Guelph/Eramosa Township Hydrogeology Agency Review Document Book

Hydrogeology Review Document Book Index

**Re: Harden Letter of June 10, 2014
Project No.: 300032475.0000**

M15 Hydrograph

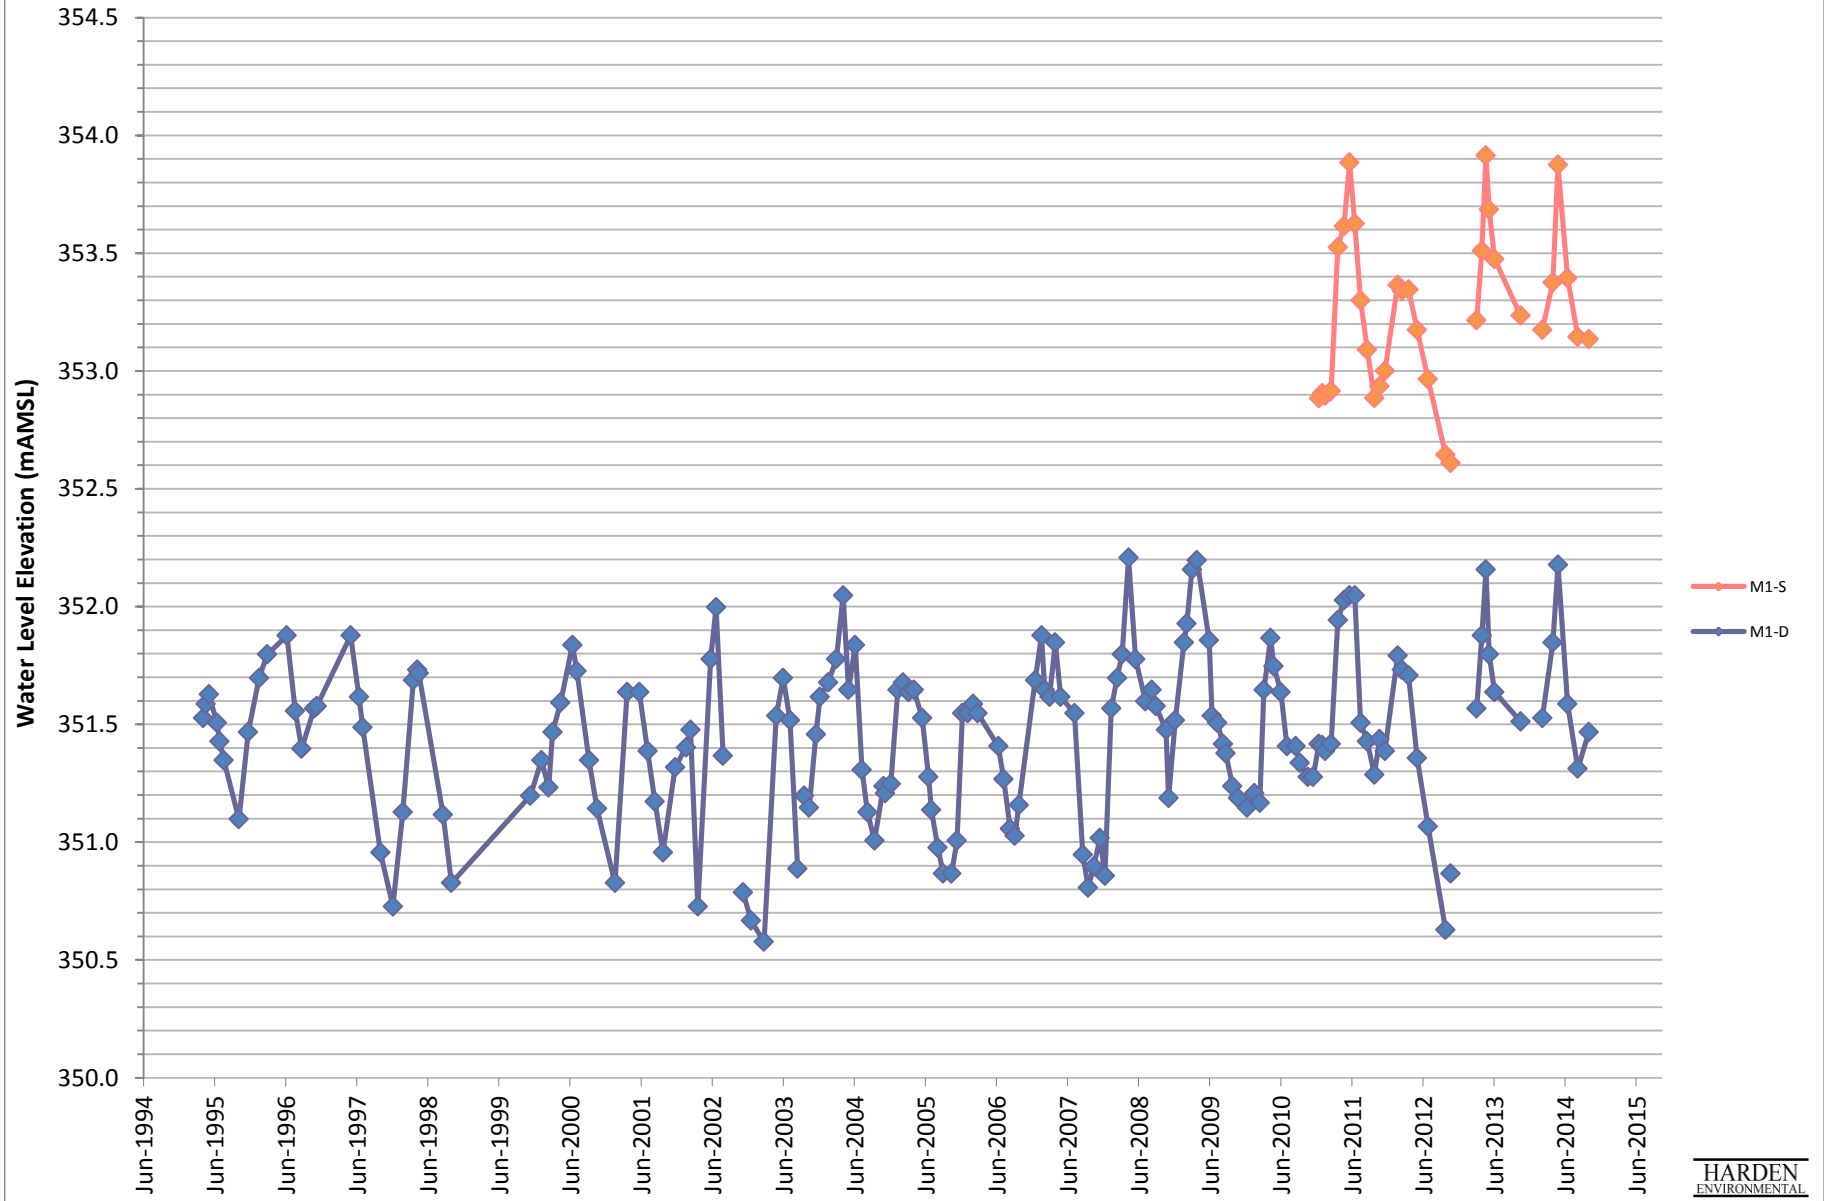
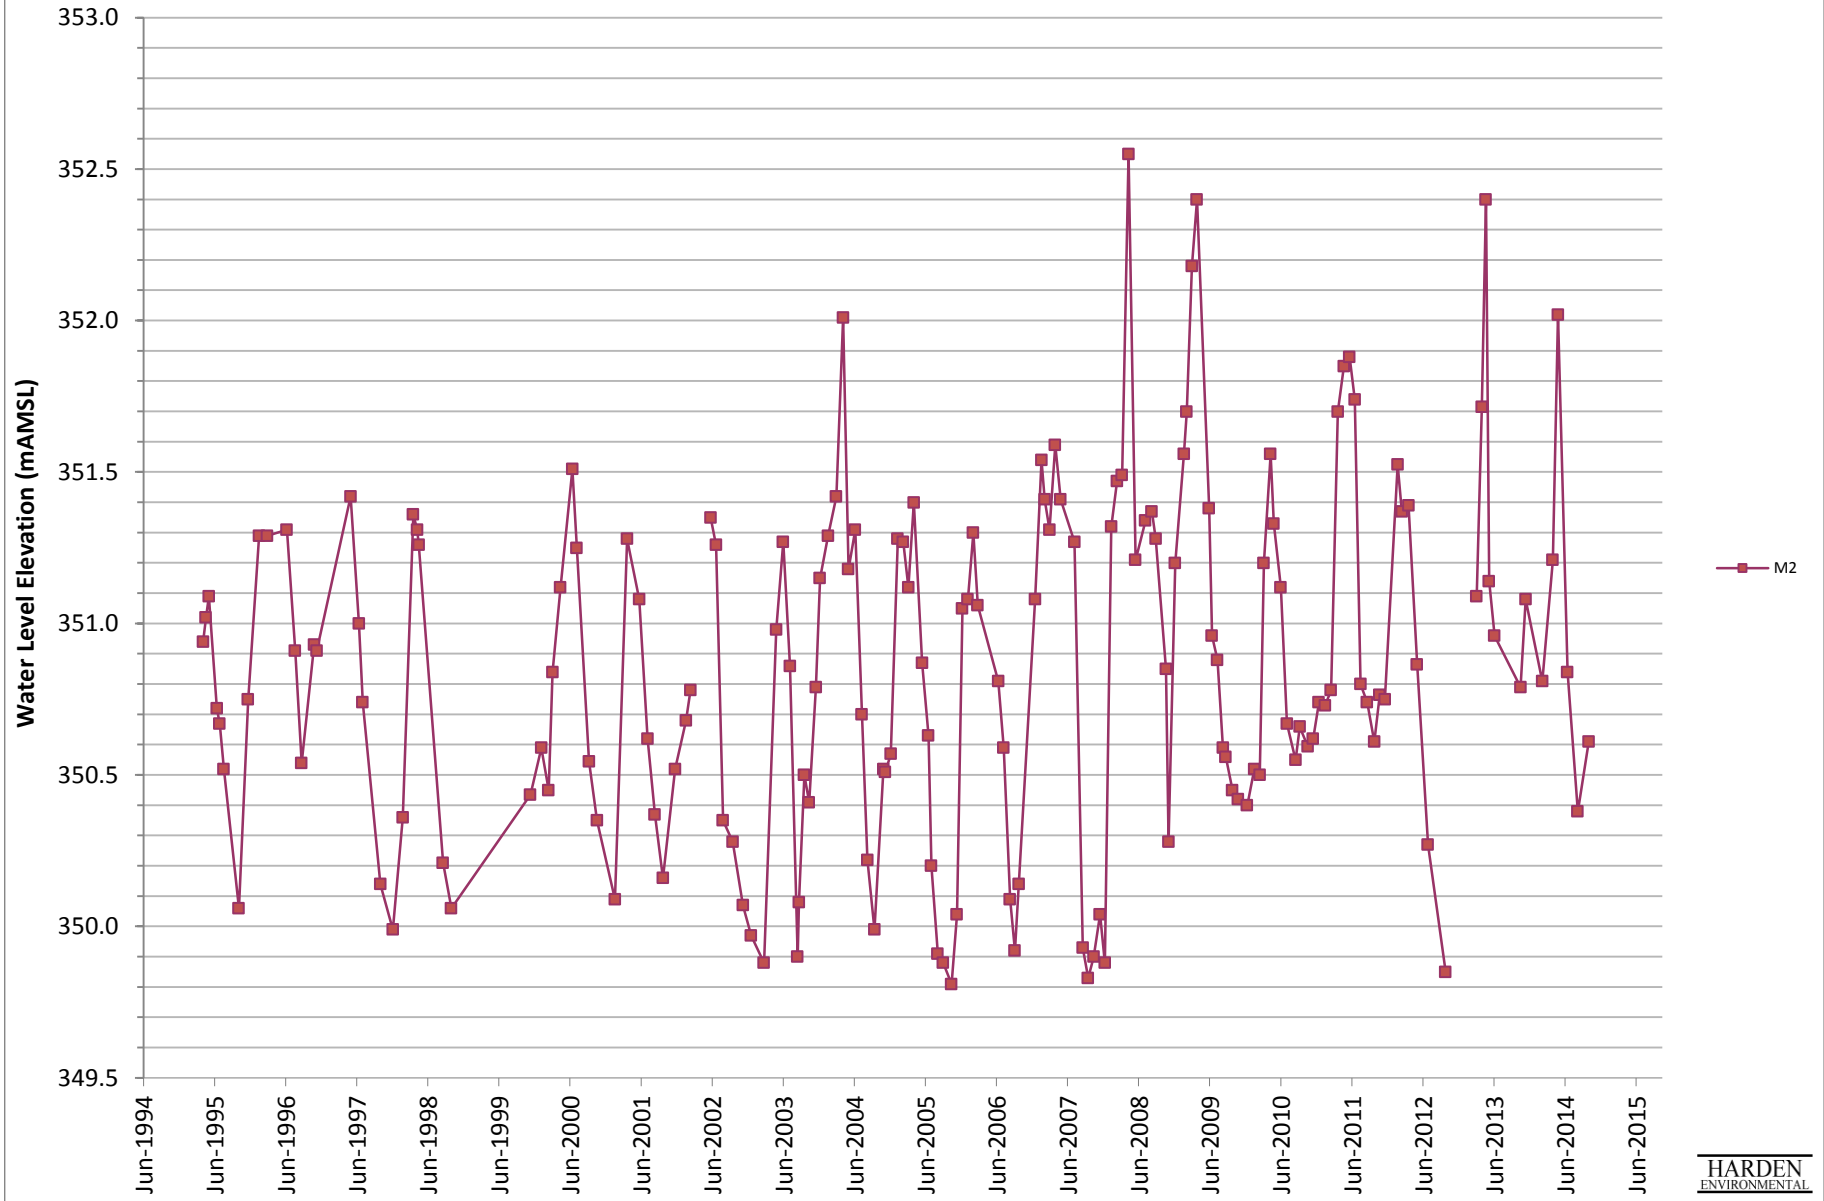
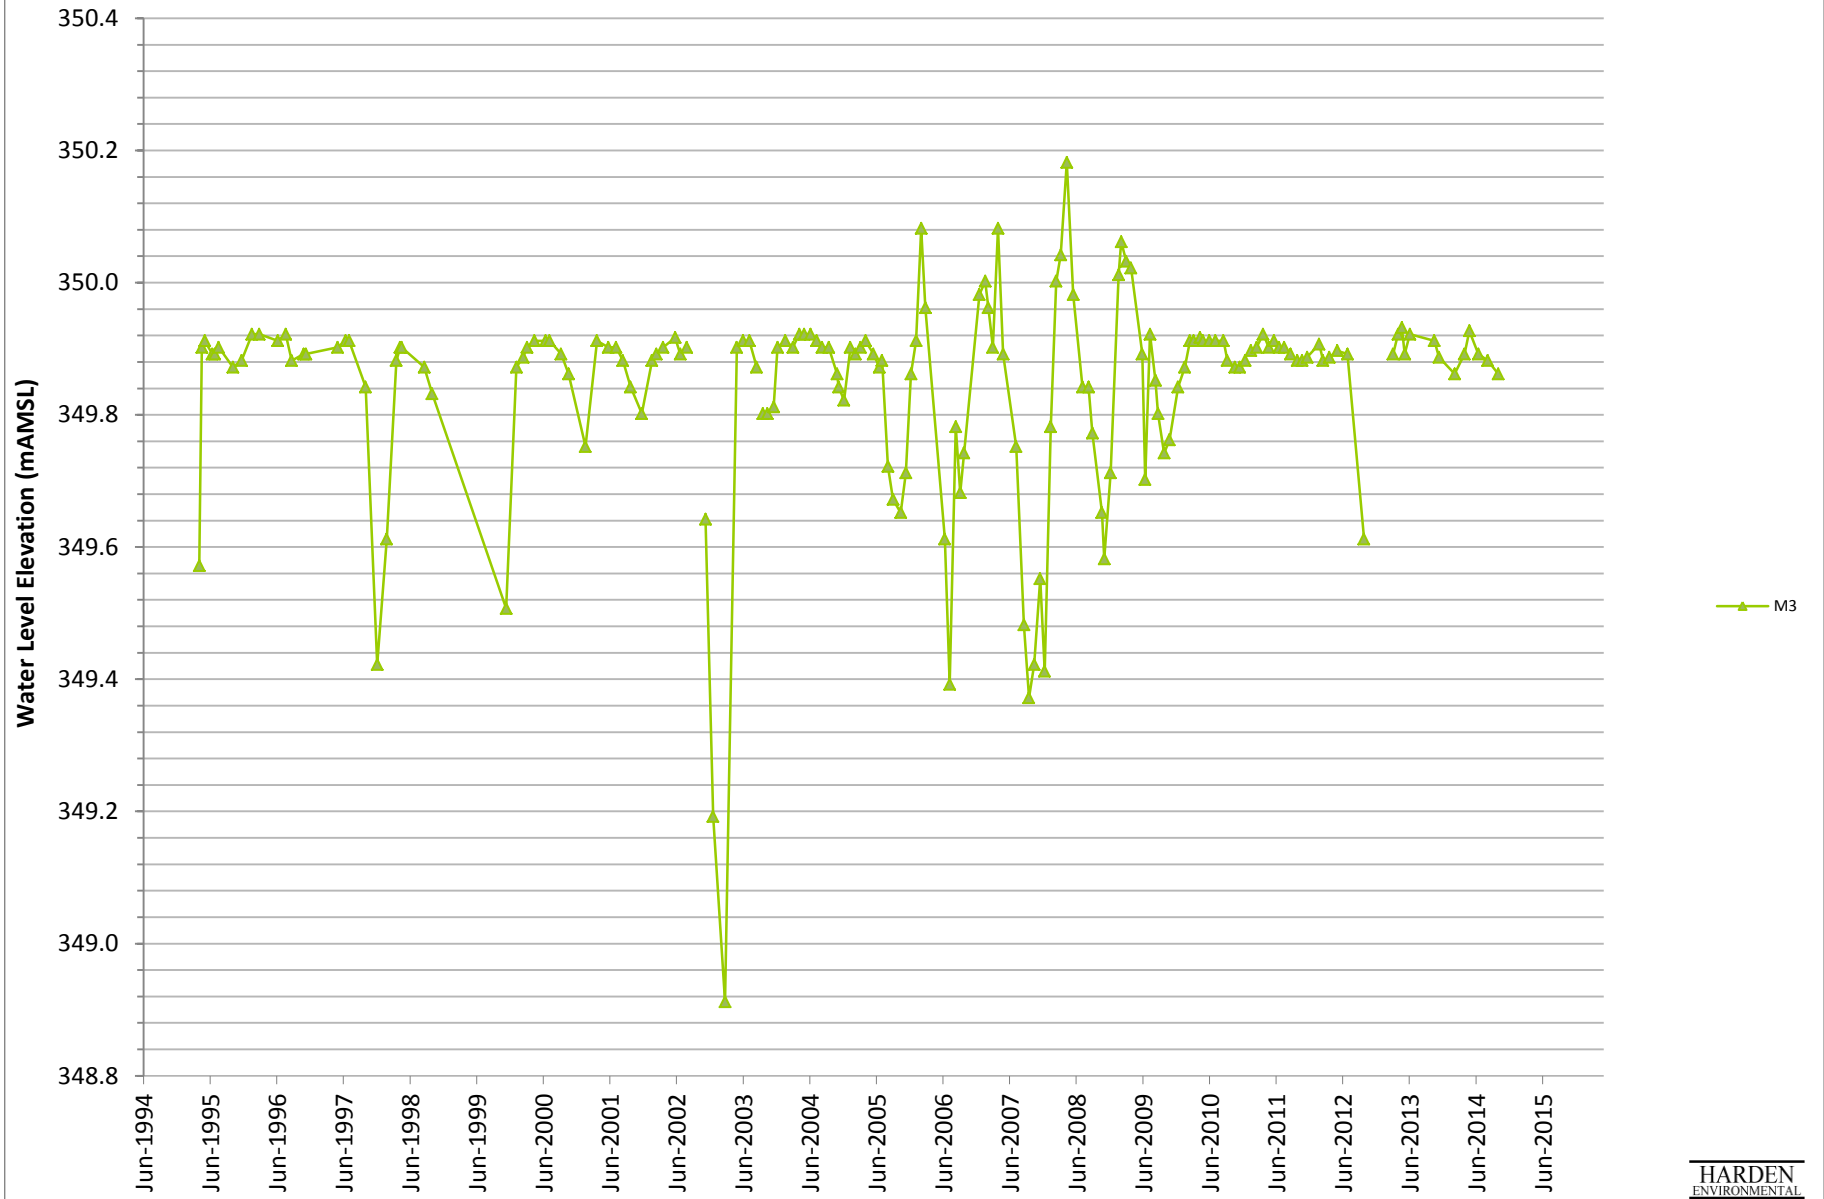
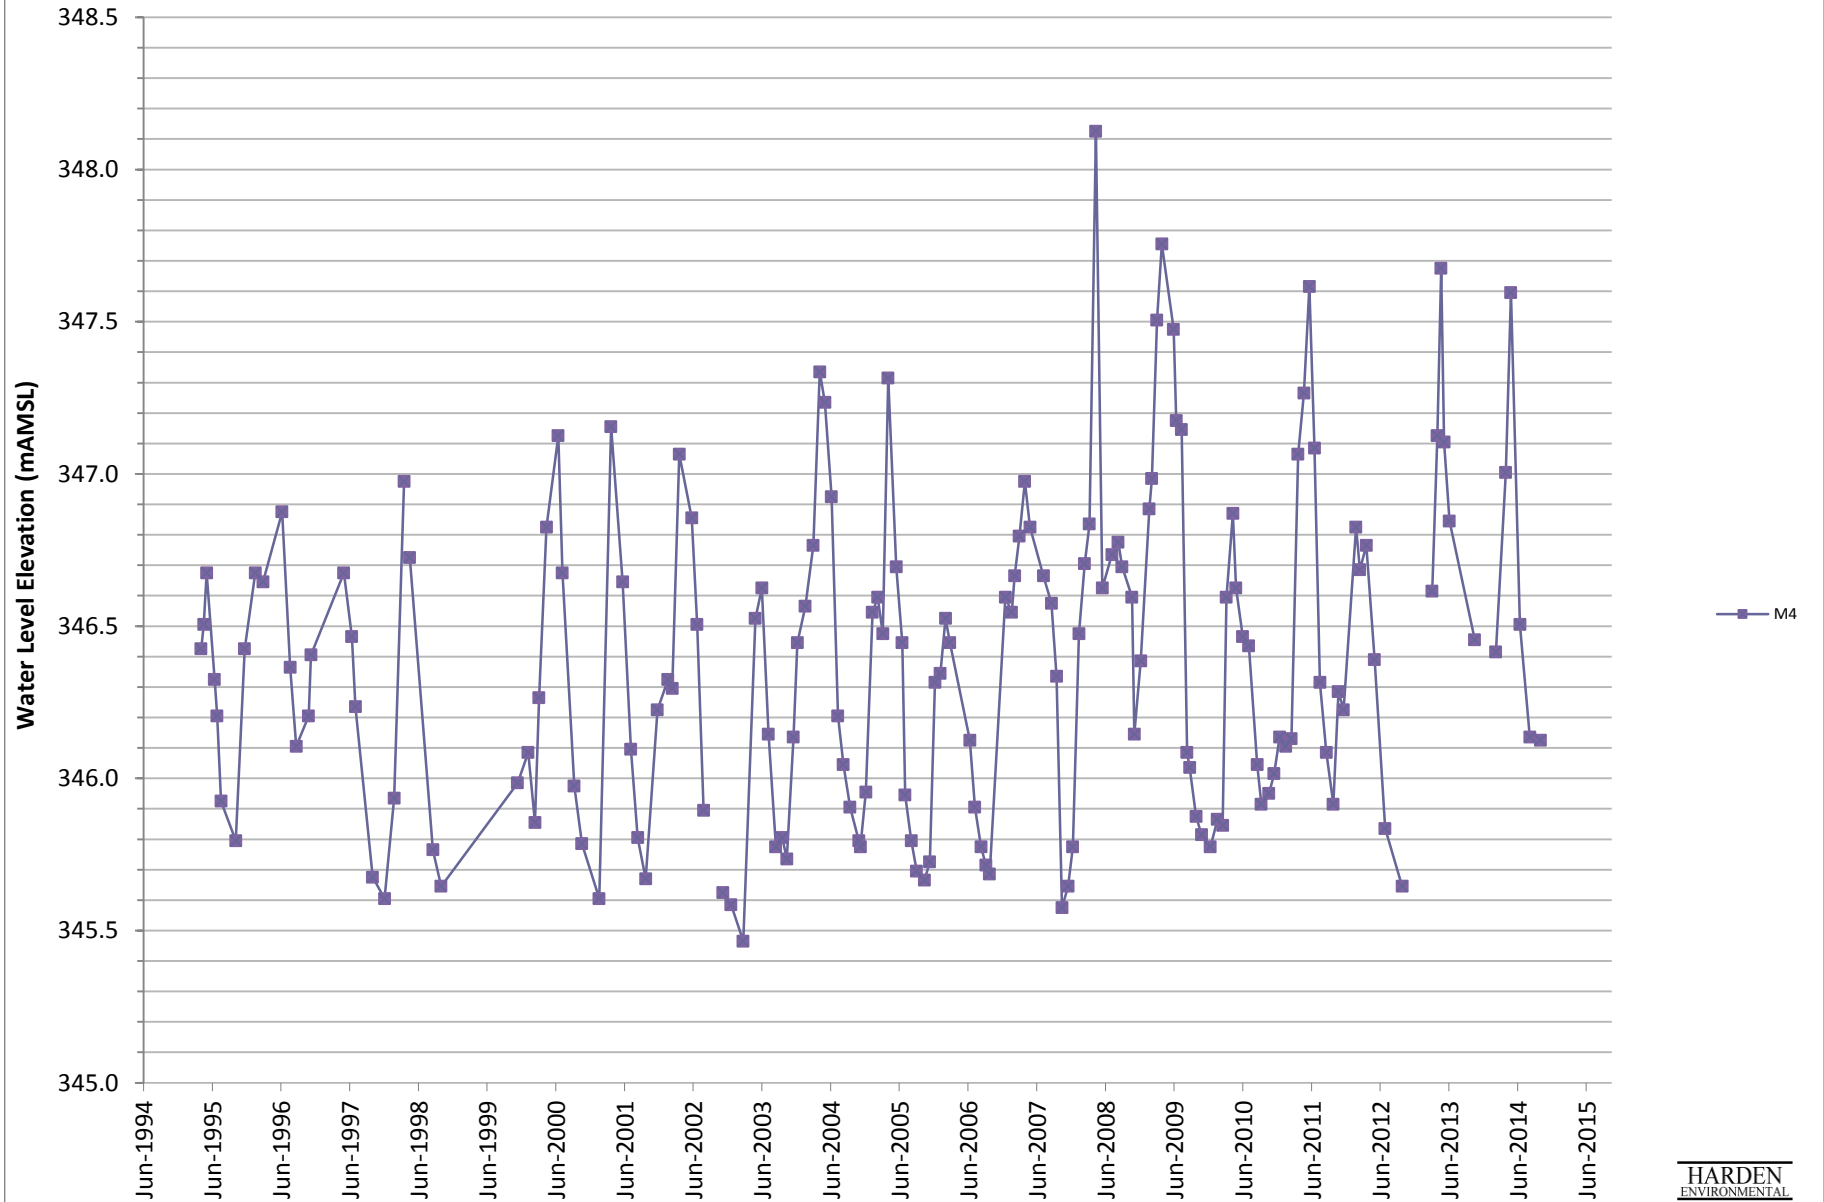
Alternatively if you prefer, please provide us with 2014 hydrograph plots for all monitors with similar horizontal (time) scale to that of M15.
